[Docket No. FAA-2011-0054; Directorate Identifier 2010-CE-070-AD; Amendment 39-16582; AD 2011-01-53]

### Airworthiness Directives; PIAGGIO AERO INDUSTRIES S.p.A Model PIAGGIO P–180 Airplanes

#### 2011-01-53 PIAGGIO AERO INDUSTRIES

Figure 1. Additional drain holes on keel beam webs

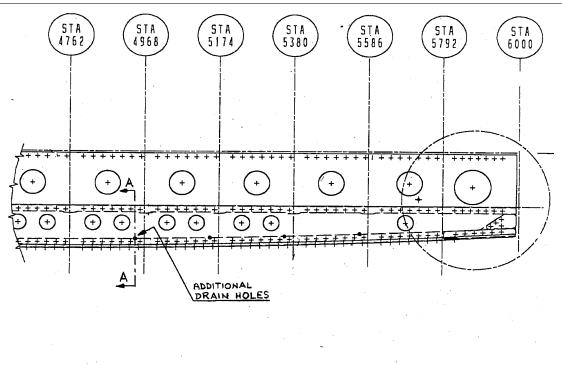
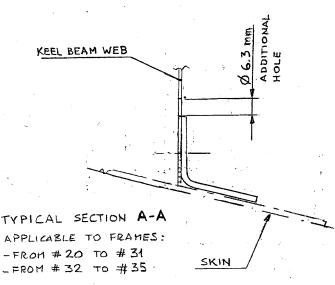
- beams), go to step 6. Step 5 does not need to be accomplished at this time.
- ii. If water is found in excess of item above (4–c–i), do step 5.
- 5. Add 6.3 mm draining holes as per attached figure 1 (additional drain holes on keel beam webs) connecting the lateral bays to the center ones or, as alternative, apply Piaggio Aero Industries Service Bulletin 80–0291. Then proceed with step 6.

Figure 2. Fuselage Drain Holes

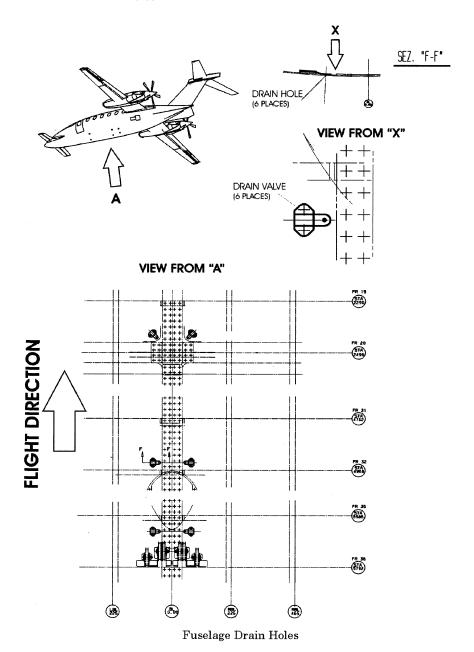
After we issued Emergency AD 2011–01–51, we realized that we inadvertently omitted figure 2 in Appendix 1. This prompted us to supersede Emergency AD 2011–01–51 and issue Emergency AD 2011–01–53.

We are superseding Emergency AD 2011–01–51 with a new AD, which was issued as Emergency AD 2011–01–53 on December 20, 2010. This AD retains the actions from Emergency AD 2011–01–51, adds figure 2 to Appendix 1, and corrects other minor typographical errors.
